Form 3160-5 (June 1990)

BUREAU OF LAND MANAGEMENT	Expires: March 31, 1993
SUNDRY NOTICES AND REPORTS ON WELLS Do not use this form for proposals to drill or to deepen or reentry to a different reservoir. Use "APPLICATION FOR PERMIT - " for such proposals	5. Lease Designation and Serial No. SF-078497 6. If Indian, Allottee or Tribe Name

7. If Unit or CA, Agreement Designation
1. Type of Well Oil Well Well Other	
2. Name of Operator Attention	8. Well Name and No. San Juan 28-7 Unit #238
Amoco Production Company Attn: Ed Hadlock	9. API Well No.

WORKOVER PROCEDURE Fruitland Recompletion

SAN JUAN 28-7UNIT #238 LOCATION 29-T28N-R7W SINGLE,DK ORIG. COMPLETION 11/74 LAST FILE UPDATE 7/91 BY CSW

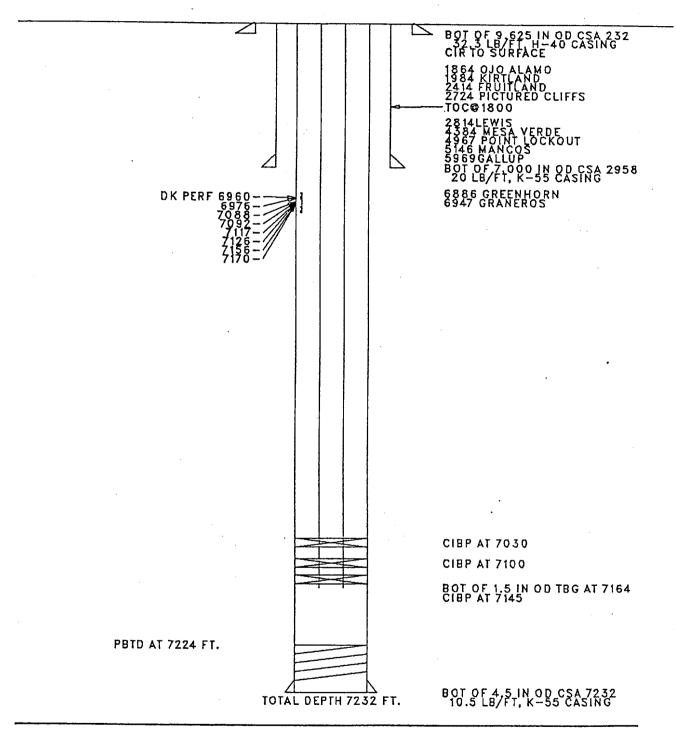
Place cement play team 3.714 to 3614 plus 30 & excensised the est

(chuca-3608)
